# UNITED STATES PATENT AND TRADEMARK OFFICE

APPLICATION NO.	FILING DATE	FIRST NAMED INVENTOR	ATTORNEY DOCKET NO.	CONFIRMATION NO.
10/776,085	02/11/2004	Dilip Tapadiya	TAPADI.003C3	2366
20995	7590	10/04/2005	EXAMINER	
KNOBBE MARTENS OLSON & BEAR LLP			BOGART, MICHAEL G	
2040 MAIN STREET			ART UNIT	
FOURTEENTH FLOOR			PAPER NUMBER	
IRVINE, CA 92614			3761

<b>Office Action Summary</b>	<b>Application No.</b> 10/776,085	<b>Applicant(s)</b> TAPADIYA, DILIP	
	<b>Examiner</b> Michael G. Bogart	<b>Art Unit</b> 3761

## **DETAILED ACTION**

FIG. 3A

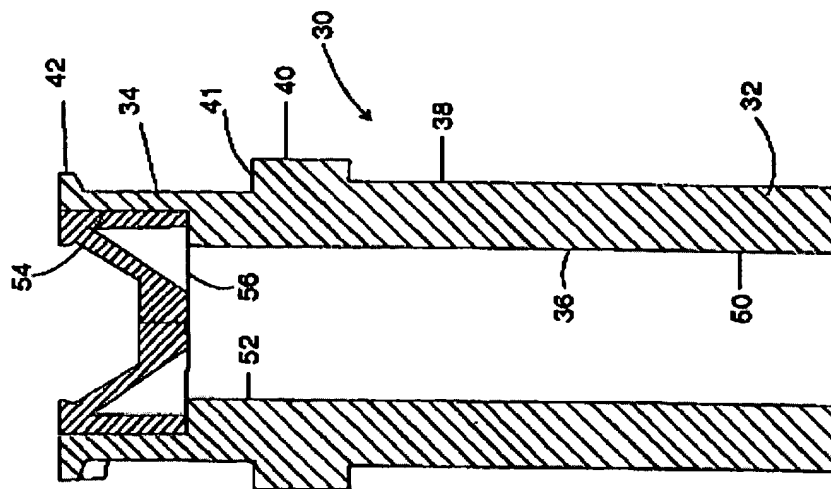
Regarding claim 127, Niedospial, Jr. teaches a medical hose kit comprising a sterilized package containing a sterilized length of hose (14), the hose (14) having first and second hose ends and a first hose inner diameter, at least a first connector (30) disposed at the first end, the first connector (30) having a first connector end defining first connector inner diameter (proximal opening) that is about the same as the first hose inner diameter, the first connector having a second connector inner diameter (56) that is smaller than the first connector inner diameter (see figures 3A and 8, below)(column 2, lines 21-41).

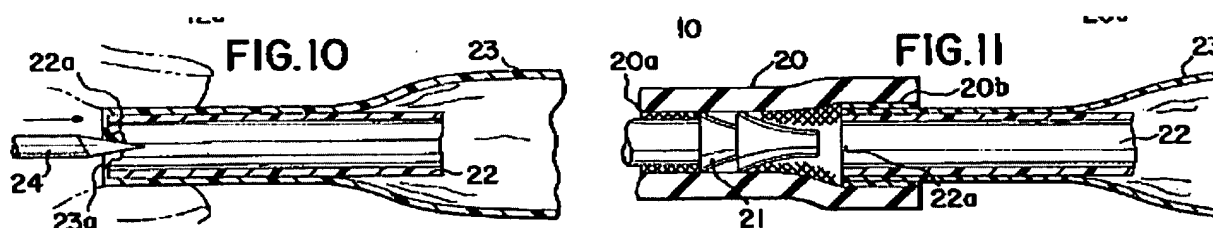
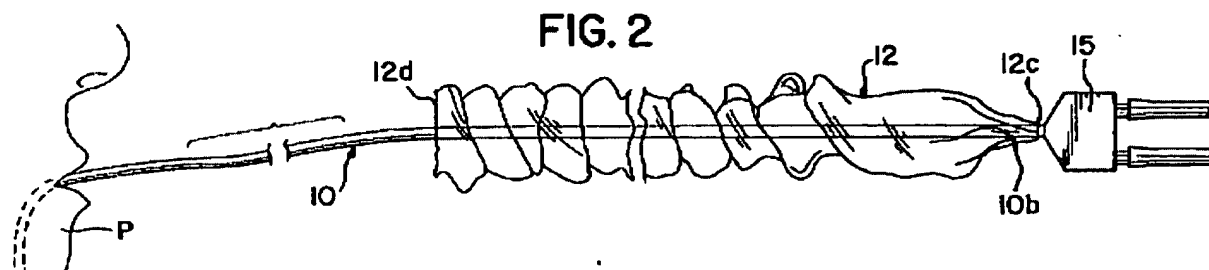
second hose ends and a first hose inner diameter, at least a first connector (20, 21) disposed at the first end (22a), the first connector (20, 21) having a first connector end (20b) defining first connector inner diameter that is about the same as the first hose (10, 22) inner diameter, the first connector (20) having a second connector inner diameter (in side connector element 21) that is smaller than the first connector inner diameter (column 4, lines 30-48)(see figures 10 and 11, below).

Regarding claim 130, Bryan *et al.* teach that the catheter (10, 22) is a suction hose that is applied for endotracheal suctioning. Structurally, this hose meets all the limitations of the claimed suction hose.

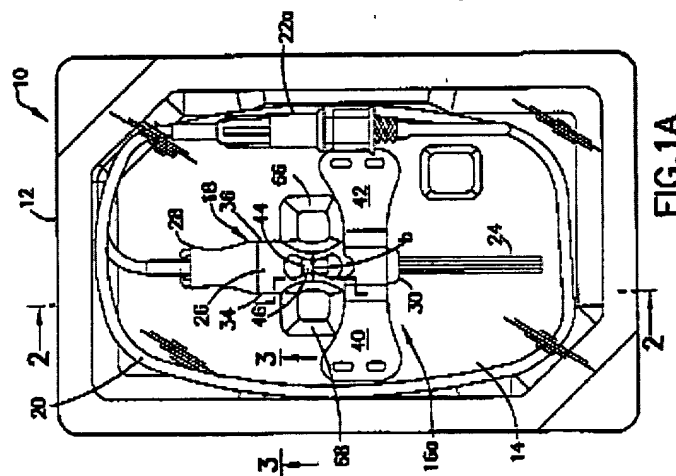
Regarding claims 124 and 128, Bryan *et al.* teach that the first female adapter (14, 20) is configured to be connectable with an outlet of a suction device (10, 20). Regarding the specific diameter, see the discussion of claim 122, *supra*.

Regarding claims 125 and 126, Bryan *et al.* teach that the first connector (20, 21) is connected to a suction device than can be held by hand (10)(figure 2).
